BAR Meeting
December 9, 2015

ISSUE: Permit to Demolish & Certificate of Appropriateness for the Construction of an enclosed front porch and rear addition; and Waiver of Front Yard Requirements; Section 3-706

LOCATION: 1212 Oronoco Street

BAR2015-00365 & BAR2015-00366

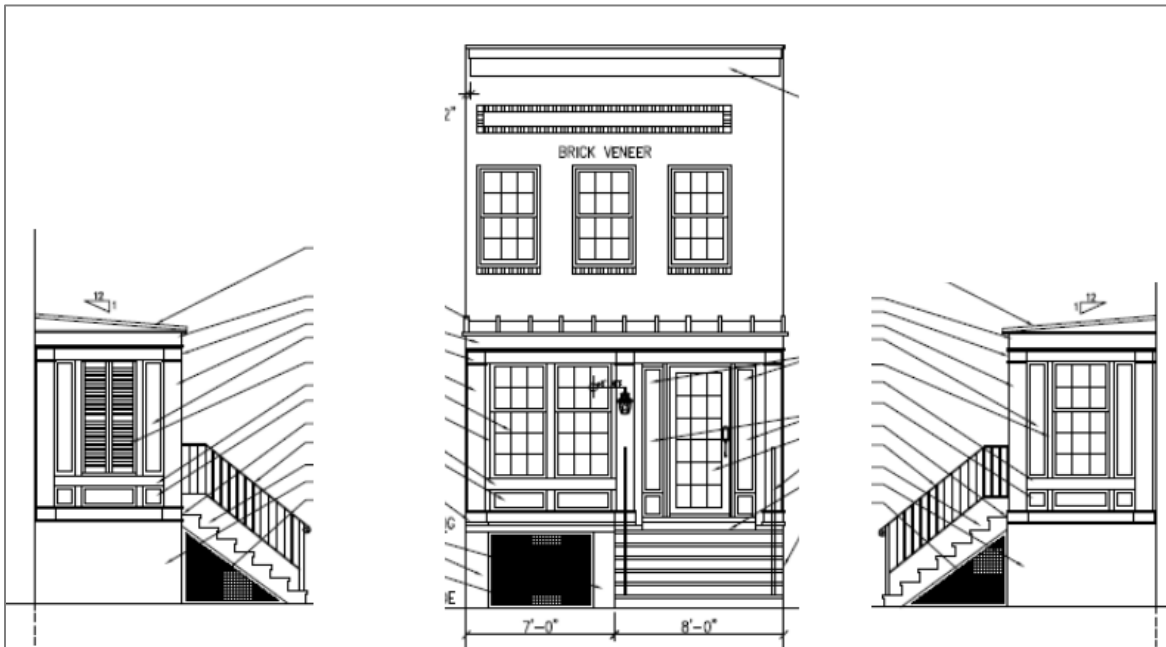
Staff has no objection to the proposed demolition of the existing stoop and stairs or to the removal of the existing rear, one-story addition. Staff does believe that the rear addition is original to the building and portions of the brick stoop and steps proposed for demolition are also original to the building, however, both the addition and the stoop have been repaired and added onto and changed over the years. In addition, they both are a relatively common design and easily reproduced, thus their removal is not a detriment to the public interest. Furthermore, the applicant is proposing to retain the front elevation's window and door masonry rough openings on the interior wall within the new, enclosed front porch. Retaining this portion of the front elevation enables a future homeowner to remove the enclosed front porch addition and easily restore the principal elevation of this building. Therefore, in the opinion of Staff, none of the criteria for demolition and encapsulation are met and the Permit to Demolish/Encapsulate should be granted.
